ADDENDUM #1

DATE: April 5, 2019

TO BIDDING DOCUMENTS ENTITLED:
CPS RFP #19/67
Columbia Public Schools
Midway Heights Elementary Masonry Restoration

PWA PROJECT NUMBER: 201621.30

DRAWING NO.
A-501-a

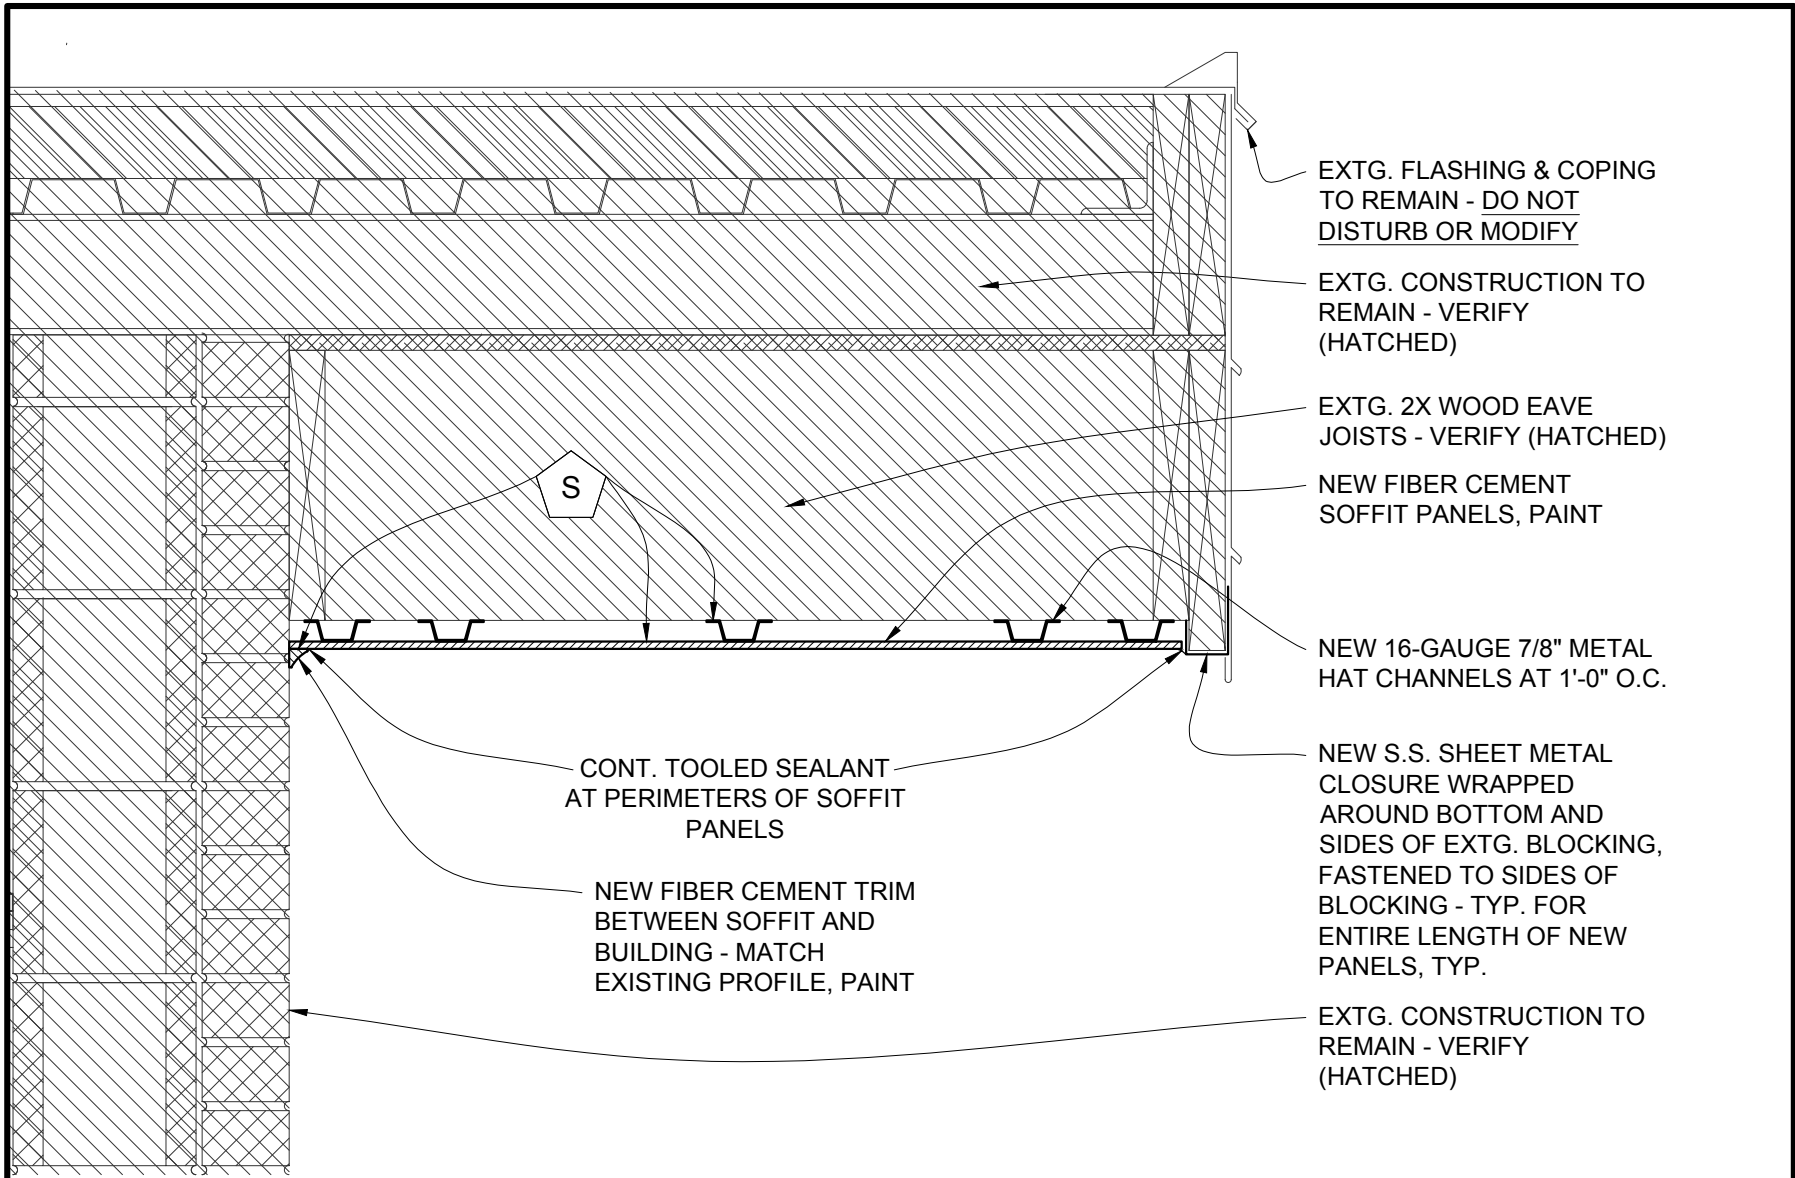
7. **Clarification:** The Owner and Architect have determined Metal Soffit Panels cannot be installed at the location shown on the drawings due to potential undesired interruption to building electrical service.

- a. Omit Metal Soffit Panels.
 - b. Omit Section 07 42 13 Metal Soffit Panels.
 - c. **Change Scope of Work Note "S" to the following:**
"Install new Fiber Cement Soffit Panels and trim at designated locations. Paint panels and trim to match existing soffit panels."

- d. All existing conduits and other electrical-service related items shown on Drawings at the locations related to Scope of Work Note "S" shall remain in place for the duration of the project and shall not be uninstalled or modified without the prior consent of the Owner. The Contractor must always maintain the integrity of the existing electrical components and service and install new Fiber Cement Soffit Panels in such a way that does not compromise this. The existing conduit supports may be fastened through the new Fiber Cement Soffit Panels into the existing joists as necessary.

- e. Refer to attached Sheet A-501-a for a detail of the Fiber Cement Soffit Panel installation per Scope of Work Note "S".
 - f. **Refer to Item #8 below regarding the revised Proposal Form and Unit Prices Form.**

NEW FIBER CEMENT SOFFIT PANELS, PAINT

NEW 16-GAUGE 7/8" METAL HAT CHANNELS AT 1'-0" O.C.

NEW S.S. SHEET METAL CLOSURE WRAPPED AROUND BOTTOM AND SIDES OF EXTG. BLOCKING, FASTENED TO SIDES OF BLOCKING - TYP. FOR ENTIRE LENGTH OF NEW PANELS, TYP.

CONT. TOOLED SEALANT AT PERIMETERS OF SOFFIT PANELS

NEW FIBER CEMENT TRIM BETWEEN SOFFIT AND BUILDING - MATCH EXISTING PROFILE, PAINT

DRAWING NO.
A-202-b

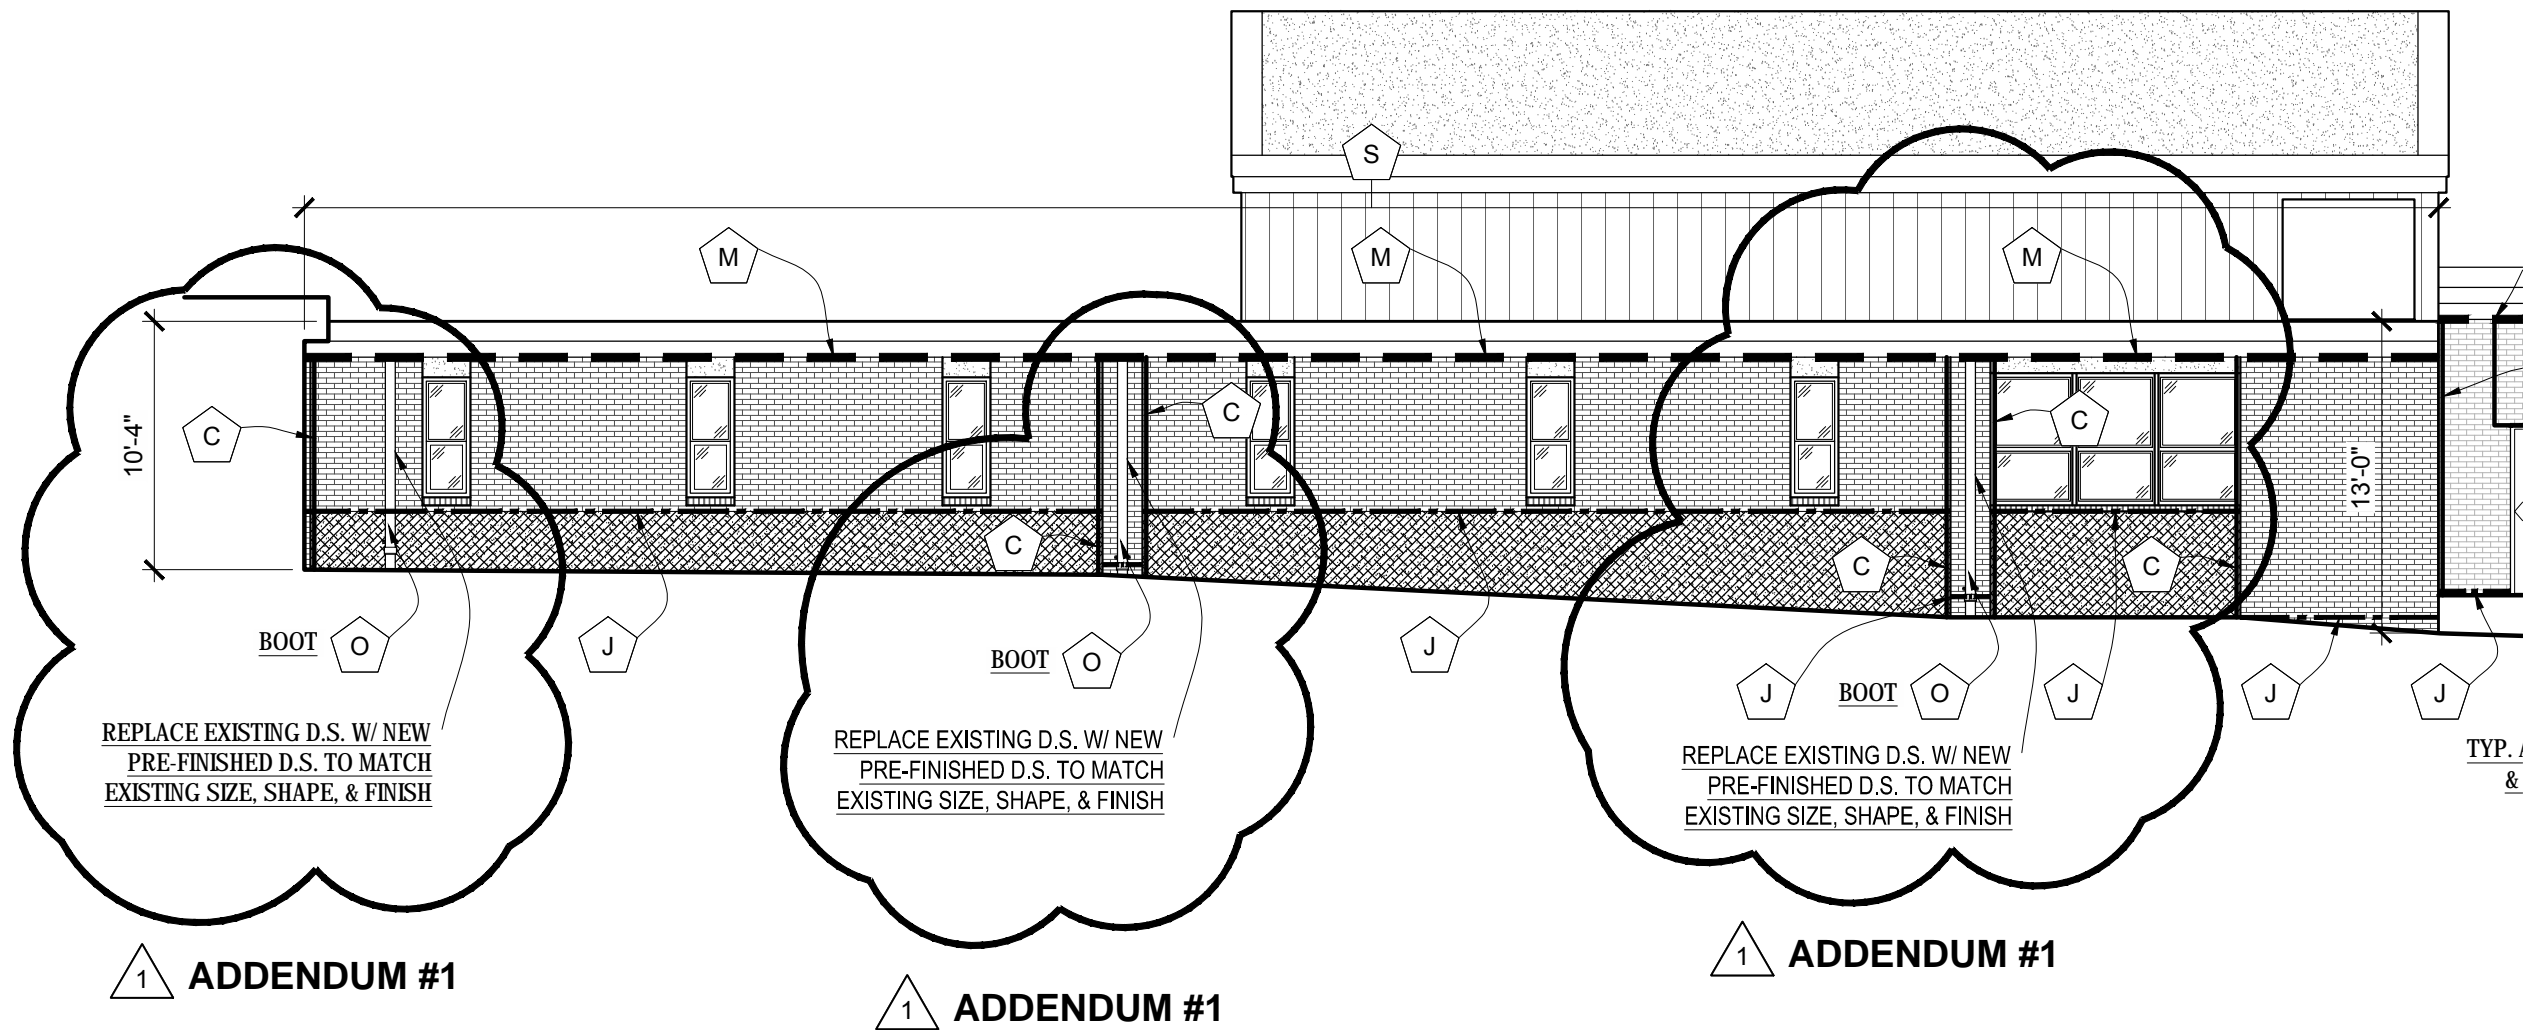
9. Add replacement of three existing downspouts shown on attached sheet A-202-b.
 - a. New downspouts shall match existing size, style, and finish and shall be pre-finished sheet metal as indicated in the attached revised Section 07 62 00 Sheet Metal Flashing and Trim.

- b. Provide 24-gauge pre-finished gutter straps to match downspout finish and profile at eight feet on center maximum, minimum two per downspout.
 - c. Finish for new pre-finished sheet metal downspouts shall be selected by Architect from manufacturer's standard finishes.
